## **ASI-07**

Project: DeIDOT Georgetown Administration Building

Project No: T202180102

SJ Project No: 20069

05/18/22 DATE  
 20069 PROJECT NO.  
 A-102 SHEET NO.  
**ASK-05**

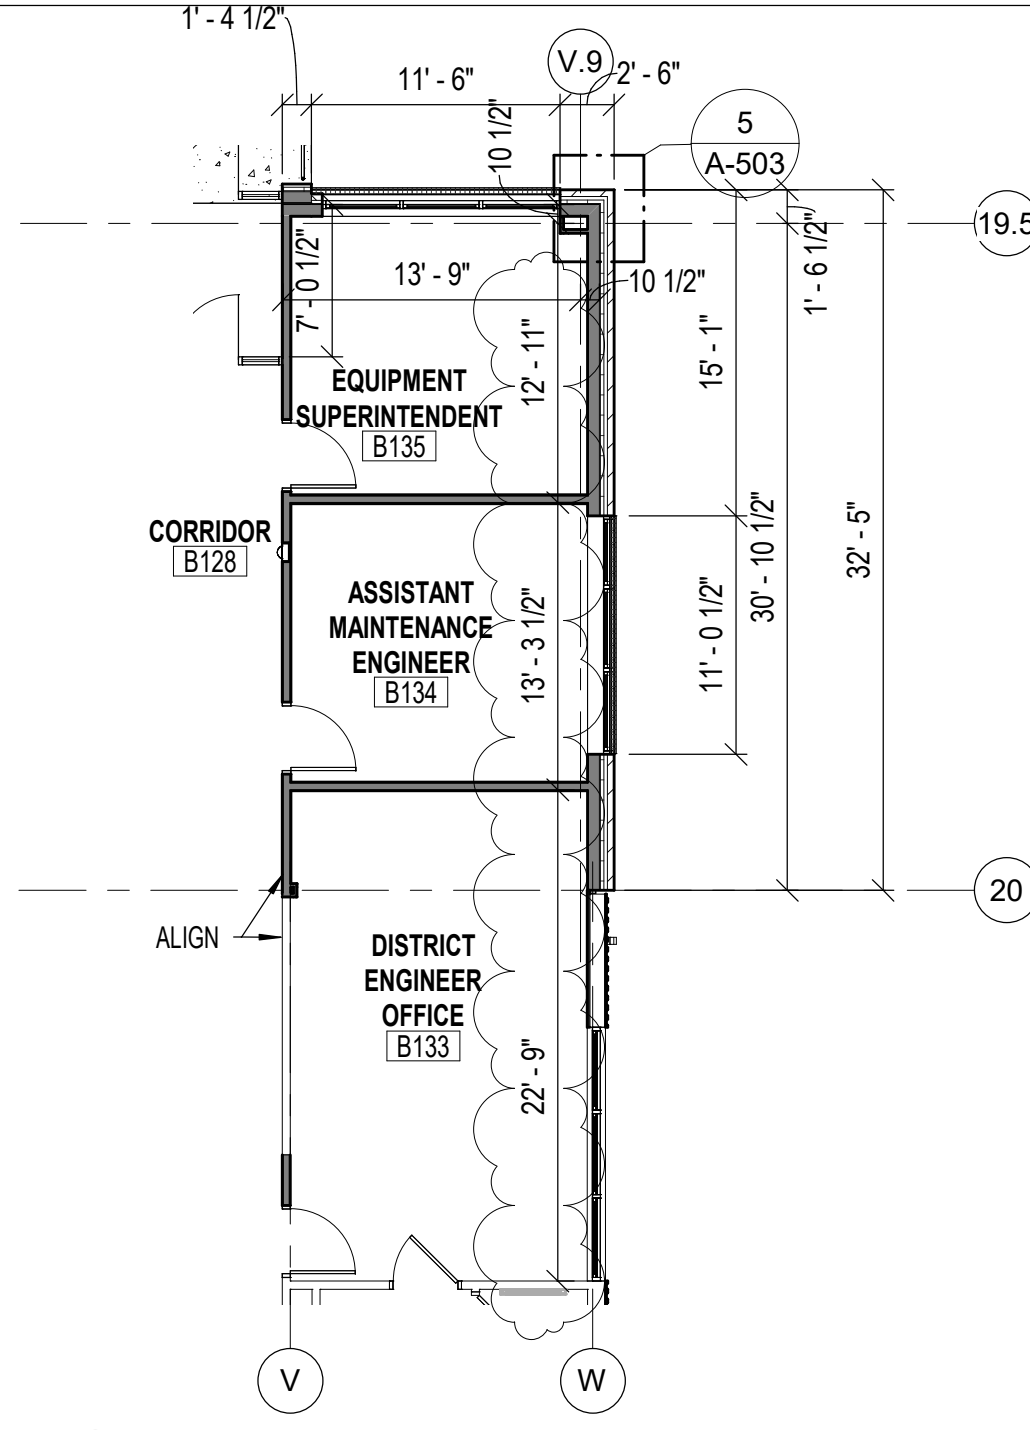
1. Align location of wall opening between A123 and A124 to line up with adjacent CMU coursing with the rough opening width to be (4) CMU courses wide, as discussed on site on May 19<sup>th</sup>, 2022.
2. Adjusted offices B135, B134 and B133.
